MAJOR SITE DEVELOPMENT PLAN

LOT 1 ACADEMY GATEWAY SUBDIVISION FILING NO. 1

DEVELOPMENT PLAN	7-ELEVEN	GRADING PLAN
LOT 1 ACADEMY GATEWAY SUBDIVISION FILING NO. 1		
PROJECT NO:	7E1024.01	
DESIGNED BY:	SPM	
DRAWN BY:	LER	
DATE:	12/04/17	
C2.0		
SHEET 3 OF 16

DATE	01/31/18
BY	SPM
REVISION	
No.	1
TEL PASO COUNTY RESUBMITTAL

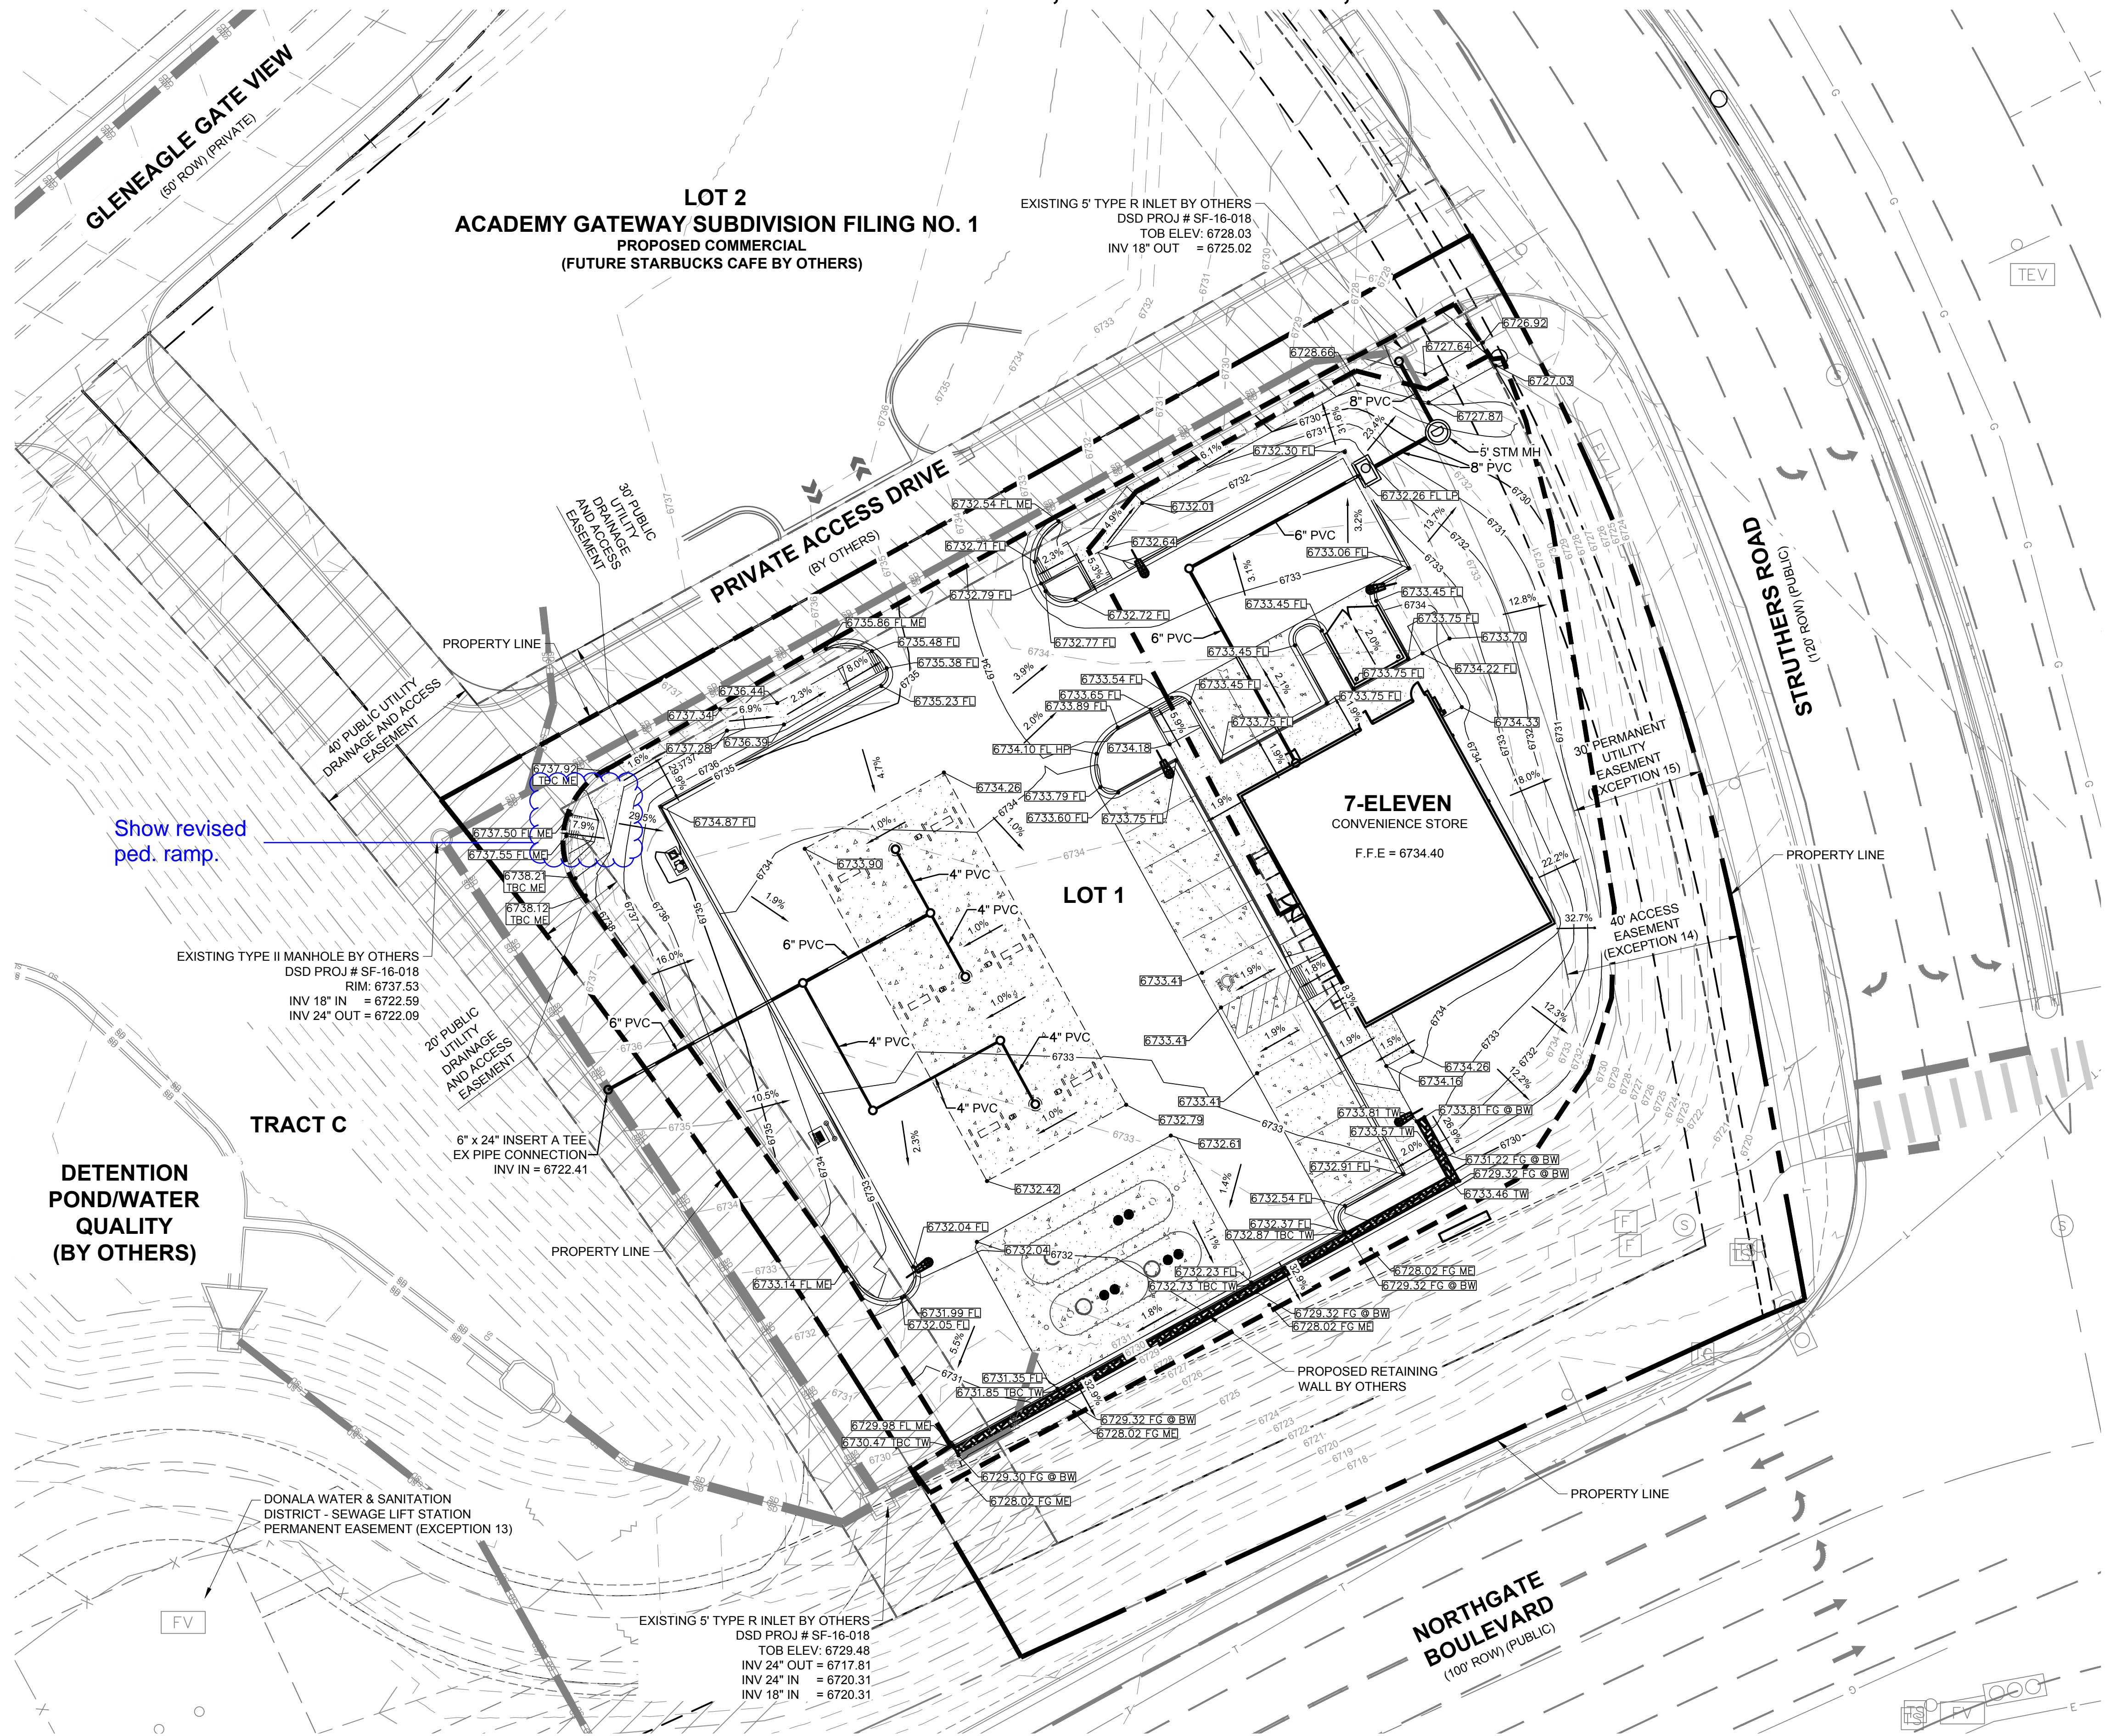
Show revised ped. ramp.
